Griffith Avenue Protected Cycle
Lane Scheme between Walnut
Rise and Charlemont Estate

Stage 3 Road Safety Audit

Document Ref: P21-105-RSA-CT-RP-001

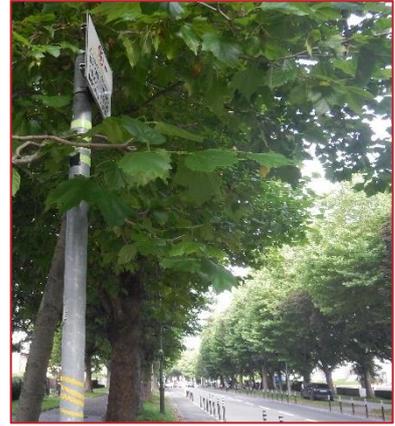
Summary: It is unclear if cyclists will be able to safely undertake right turns at signalised junctions within the Scheme.

Advance stop lines have been provided for right-turning cyclists at signalised junctions within the Scheme. The volume of right-turning cyclists from Griffith Avenue at the signalised junctions within the Scheme is unknown however, on a red signal, cyclists will be able to enter the advance stop line from the protected cycle lane and proceed on a green cyclist phase, which receives a green signal a few seconds in advance of vehicular traffic. However, on a green signal cyclists may be unable to safely exit the protected cycle lane and take up the correct position for turning right as this would require weaving across the adjacent traffic lane where there is an increased risk of being struck by a vehicle.

This may therefore lead to less confident cyclists using the pedestrian crossings at the junctions to enter the side road to the right. These crossings, however, are not toucan crossings and may not accommodate both pedestrians, and cyclists when waiting and using the crossing increasing the risk of conflicts.

Toucan crossings should be provided at the signalised junctions within the Scheme to facilitate right-turning cyclists with the cyclist push button located where a cyclist can trigger a crossing phase from the stop line in the protected cycle lane.

Alternatively, if possible and the volume of right-turning cyclists requires it, cyclist 'box-turns' (Section 4.6.3 of the National Cycle Manual) should be provided at signalised junctions to facilitate right-turning cyclists.

3.11	Yes	No	It is considered that toucan crossings are not warranted at minor signalised junctions along this route. In such cases less confident cyclists can wait if necessary for a red signal which will allow them enter the ASL and make a right turn when they get an advanced green signal. The main junctions on the scheme are being upgraded to accommodate right turn movements for cyclists either as part of this project or future Bus Connects works.	Yes
